Re: Crestwood Estates

POADP # 684

REQUEST FOR REVIEW of POADP

Re: Crestwood Estates
Preliminary Overall Development Plan (POADP)

CRESTWOOD ESTATES, A PLANNED COMMUNITY

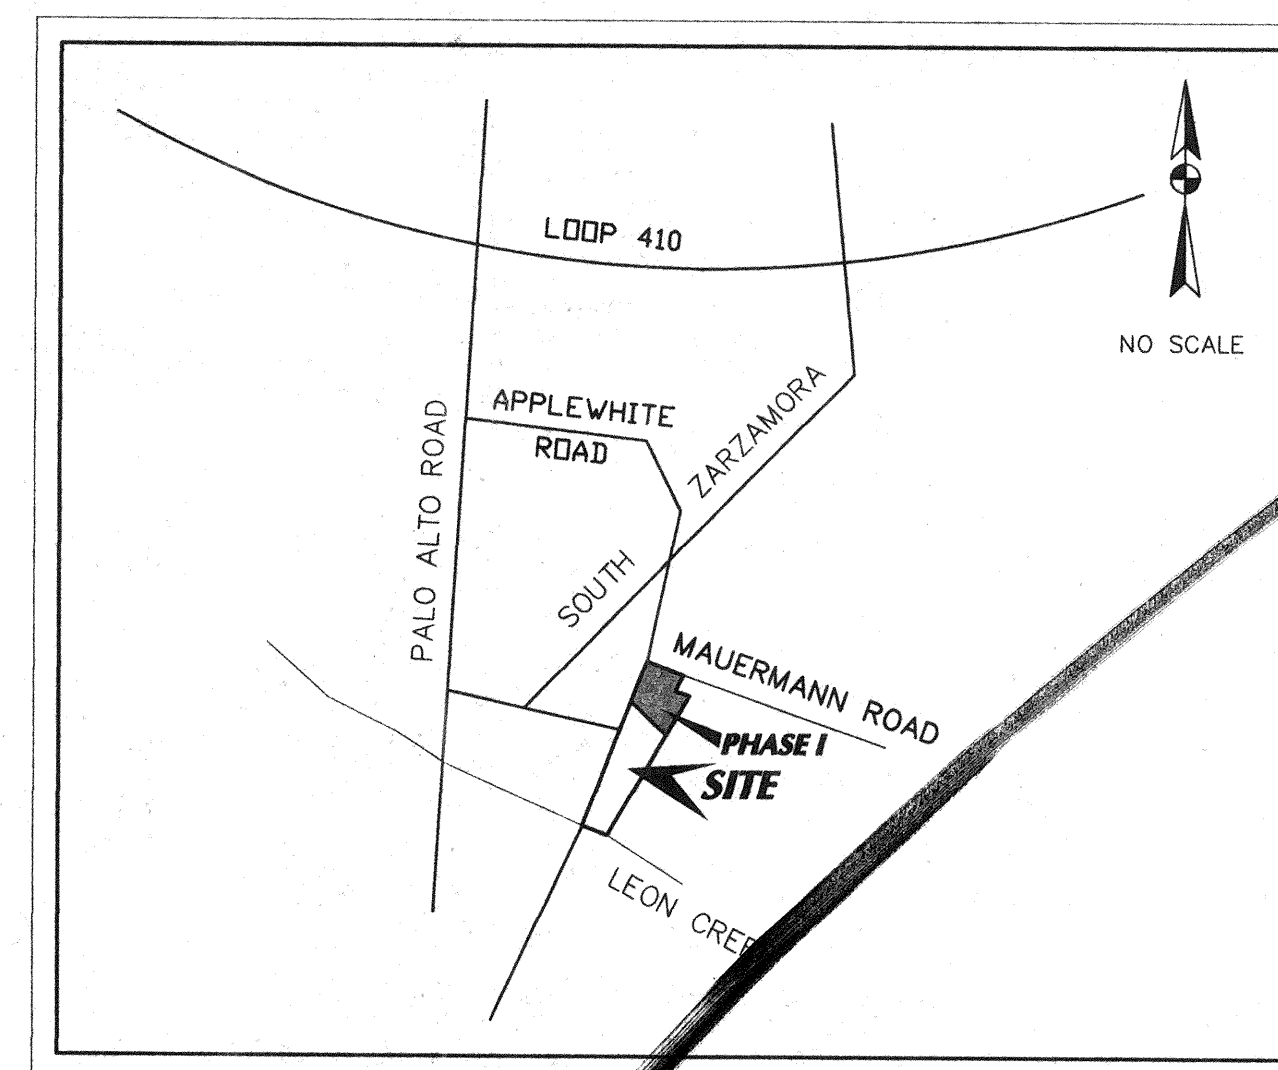
show
this
phase
info
graphically

need
legal description
avg. area
lots
density
rec. area
calc.
